Warrenton Planning Commission
AGENDA
January 14, 2021 | 6 PM | City Hall – Commission Chambers

To: Warrenton Planning Commission
From: Scott A. Hess, Community Development Director
Re: Fort Pointe PUD Application - SUB 20-2

To: Scott Hess, Building Official
Van Wilfinger, Building Official
Date: December 22, 2020
From: Brian Alsbury, Fire Chief
Re: **Fort Point, Hammond**

ACCESS:

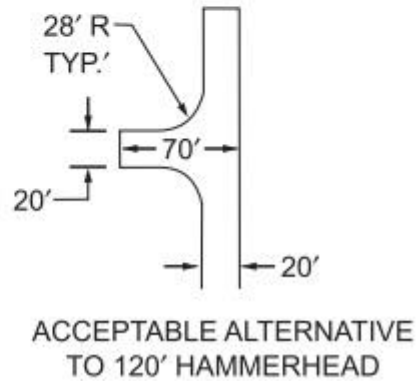
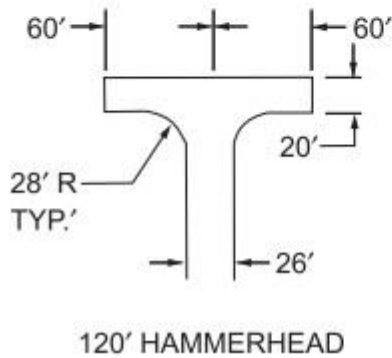
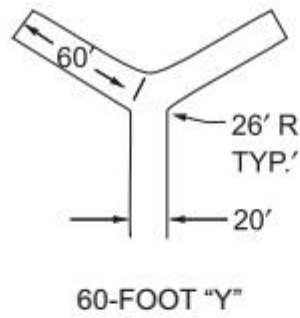
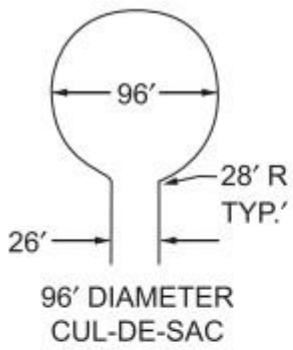
Oregon Fire Code, table **D103.1** shows that any dead-end road that will be used for fire access will need to have a 120-foot hammerhead, 60 foot “Y” or a 96-foot cul-de-sac in accordance with figure **D103.1** (see 2nd page).

C3.2

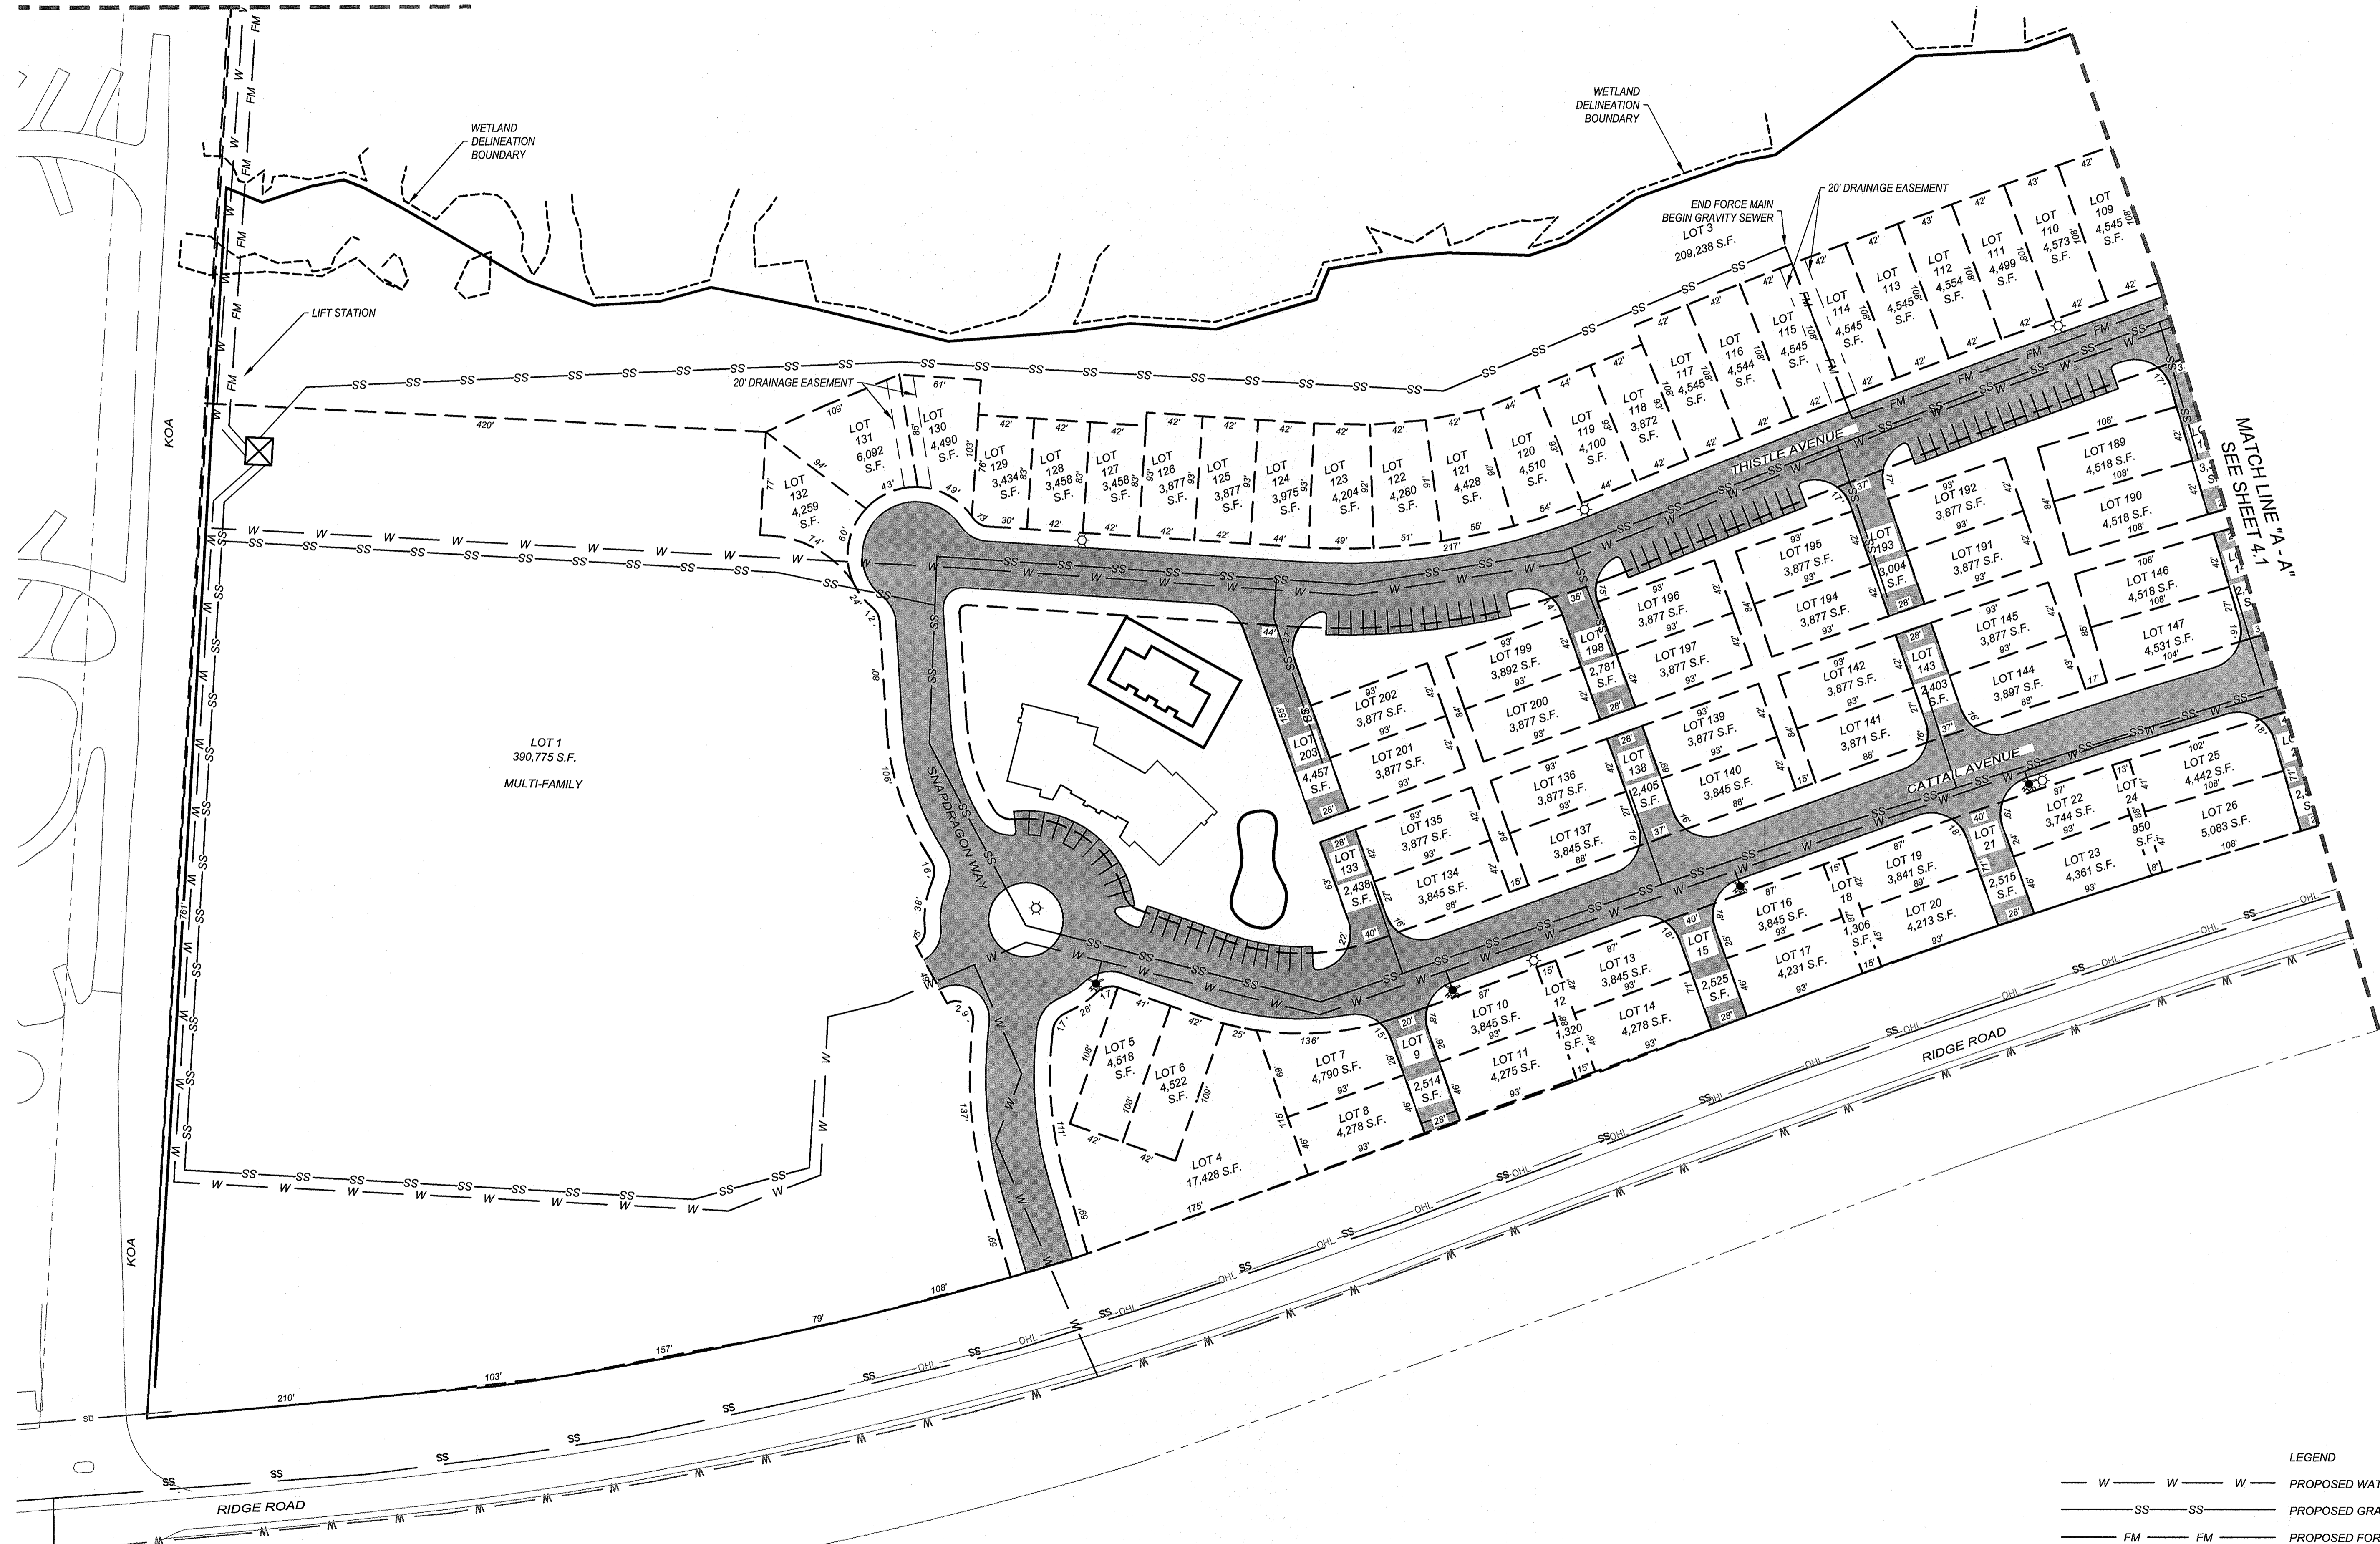
Section 3.1.10 Alleys: Example – Lot 138, Sheet C4.0 – is that an alley allowing access to the 4 adjoining lots? Does it go all the way - thru to Lot 198? Concern is for fire and vehicle access.

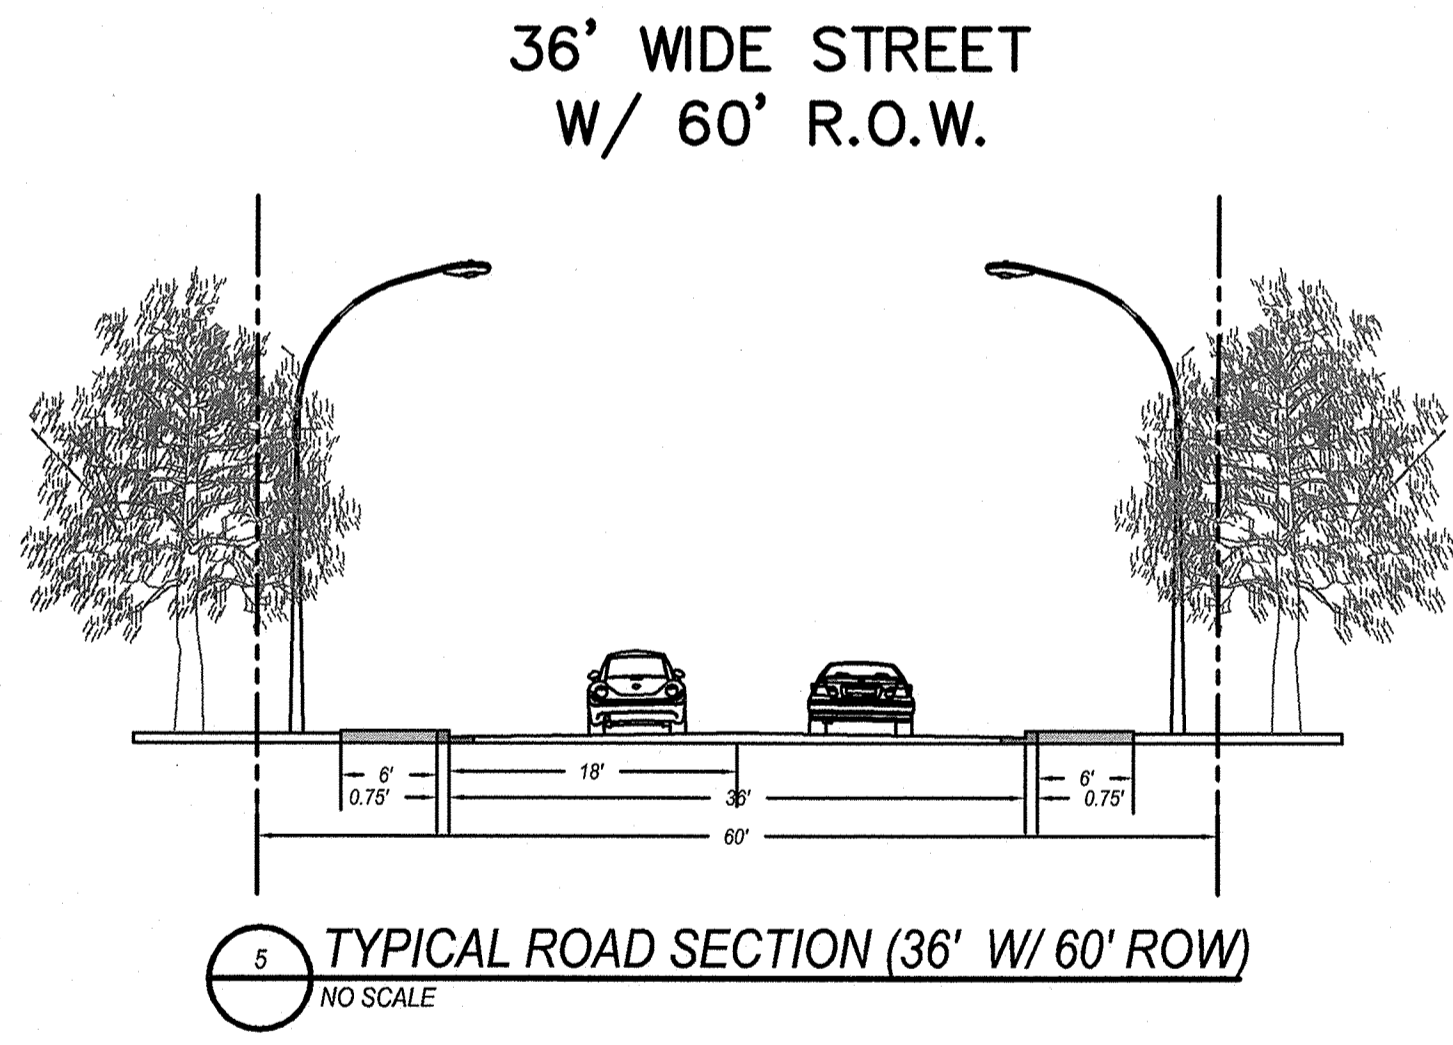
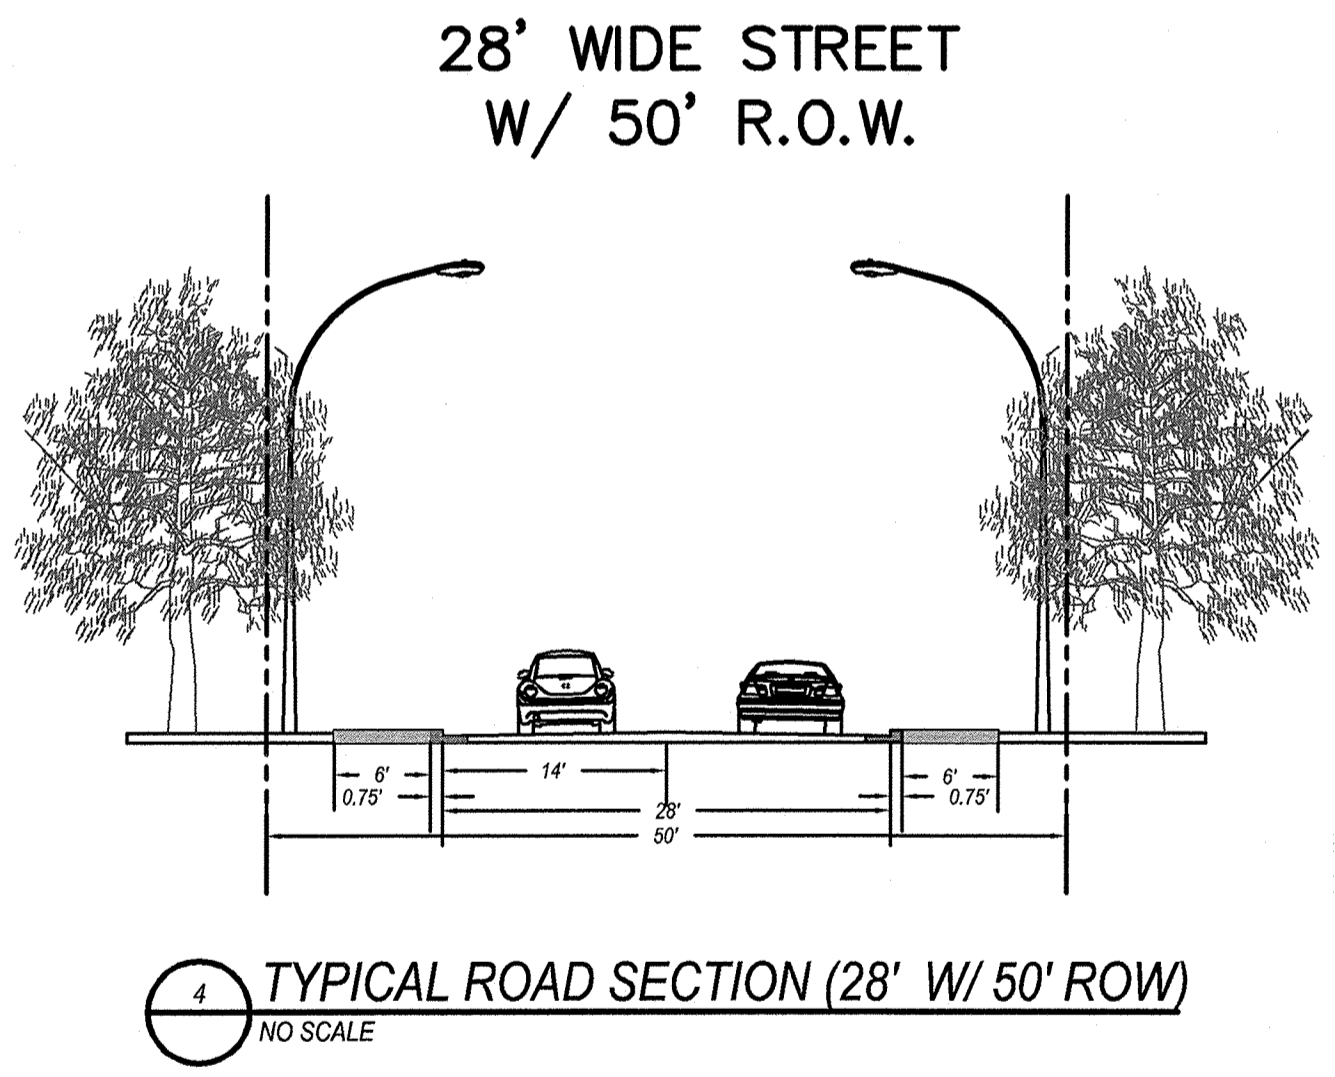
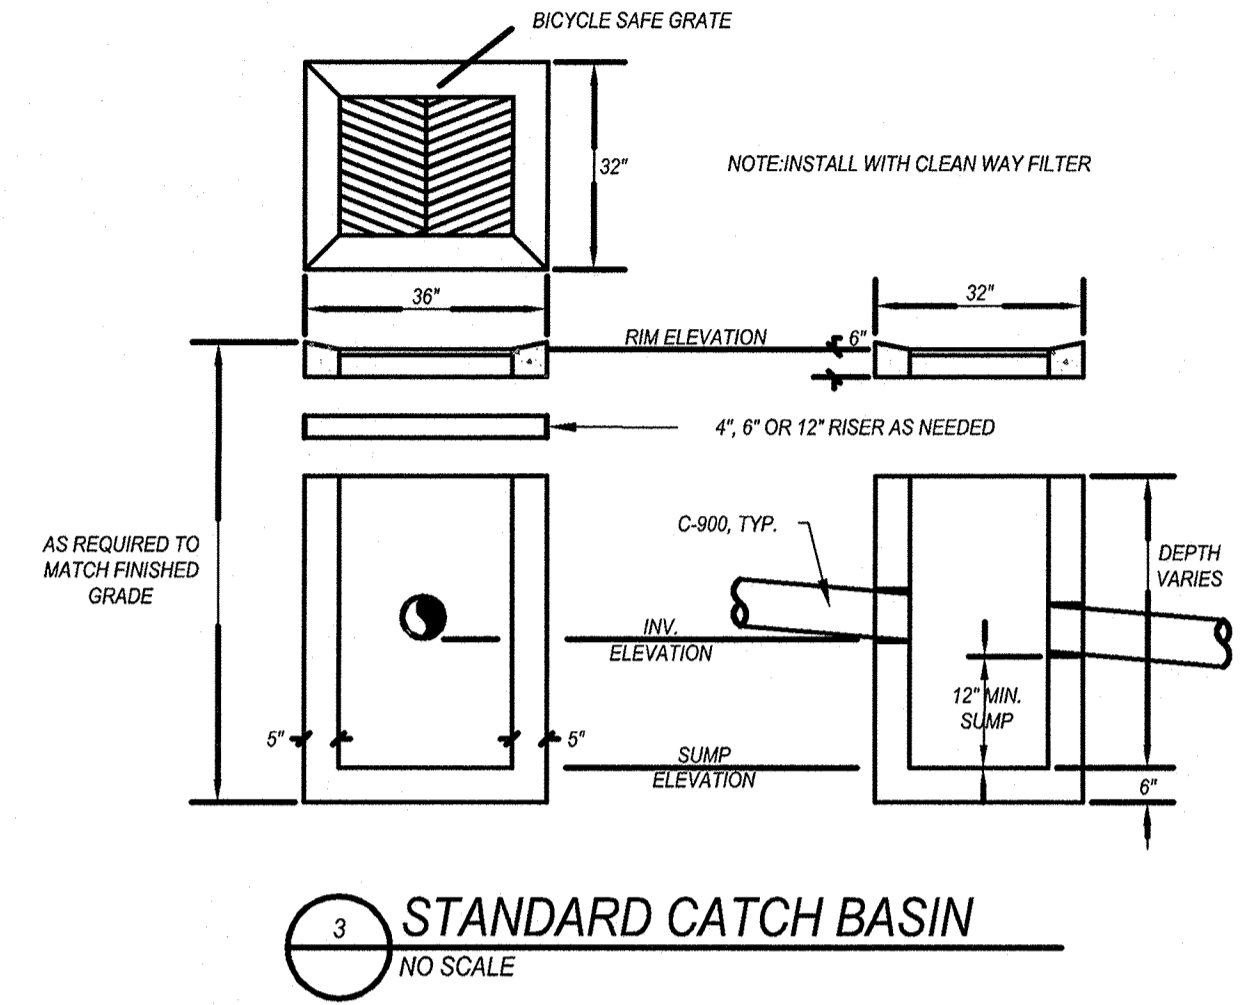
- HDPE pipe - for the mainline connection from Ridge Road to NW Warrenton Drive. This would provide one continuous line from point to point – with minimal joints to leak.
- Trench Detail 2, Sheet C6.0. Since most of the trenching will be thru sand – the trench width will be wide depending on the depth of the pipe. I would recommend asking the question about Item #2 TRENCH BACKFILL – change to 'clean native backfill' as a cost
